**Our Case Number:** ABP-318573-23

**Re:** A proposed Road Development comprising of the N2 Slane By-Pass and Public Realm Enhancement Scheme  
Within the Townlands of Slane, County Meath

**RE: N2 Slane Bypass and Public Realm Enhancement Scheme**

This map shows the location of the proposed bypass in relation to the World Heritage Property, Knowth and the Hill of Slane. *Vol. 1 Non-Technical Summary*

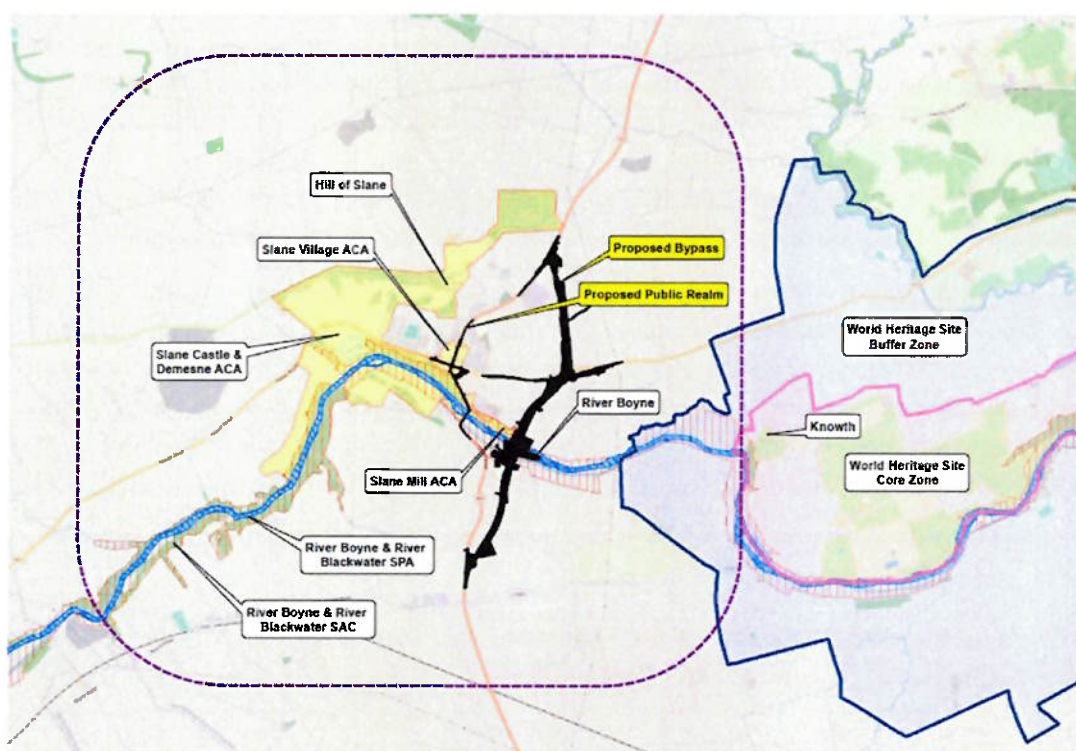
The current N2 is located at least 2.7km from the WHP Core Area and at least 1.4km from the Buffer Zone. The proposed Slane Bypass, at its closest where it crosses the N51, is approximately 0.9 km outside the Buffer Zone and 2 km outside the World Heritage Property. This is 500-700 metres closer to the Core Area and Buffer Zone than the existing N2. Knowth Passage Tomb is very close to the western boundary of the Core Area.

Detail of VPT 01, focussing in on the southern approach to the proposed new Boyne Bridge and the Rossnaree overbridge: Year 10

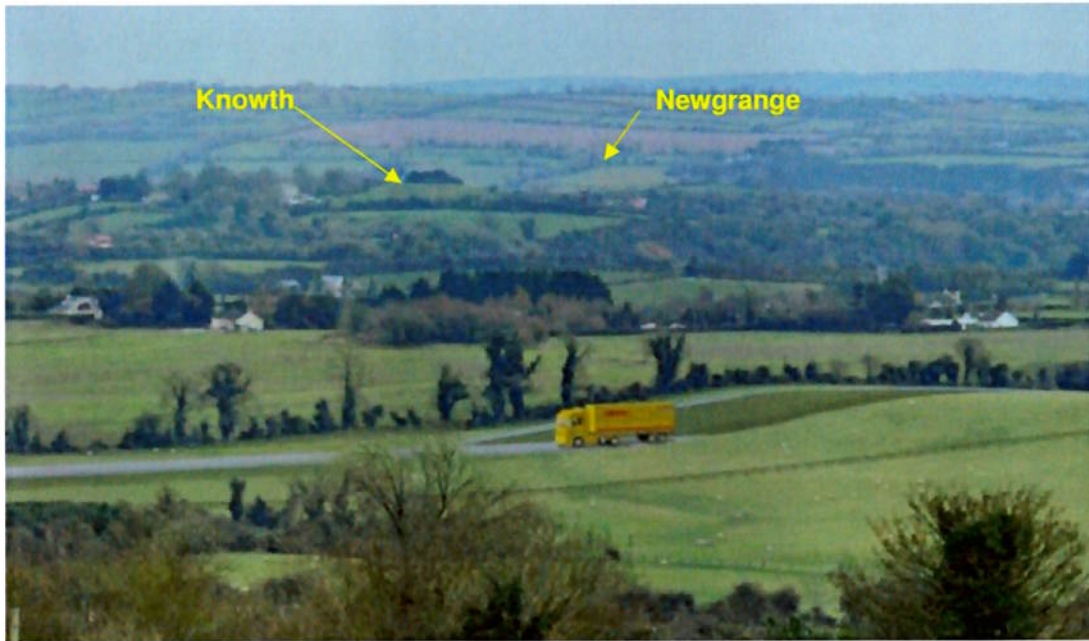
Part of the mitigation strategy is that increasingly, over a period of 10 years, the hedgerow planting with trees will conceal high-sided vehicles on the road to the south of the proposed N2 Boyne Bridge. The OPW notes that the positioning of the proposed N2 Boyne Bridge has reduced the visibility of it to 35 metres on Year 1 of the southern end of the bridge and the southern abutment, reducing to the 25 metres of bridge 10 years later. The 10-year photomontage (VPT 01) demonstrates that it is not feasible to screen the view of vehicles crossing the proposed bridge. It is unclear to the OPW, what a structure at higher level is within the photomontages, possibly the Rossnaree overbridge, which is mostly screened in the Year 10 photomontage. The sinking into a cut of the N2 approach to the bridge reduces the visual impact on Year 1; planting will progressively conceal the upper parts of high-sided vehicles over a 10-year period.

Noise from the existing N2 is currently audible from Knowth under some atmospheric conditions. The proposed road will be closer to Knowth. *Appendix 9.5 Operation Noise Prediction with Mitigation* predicts that noise at R1320 at Knowth will change from 46dB to 47dB.
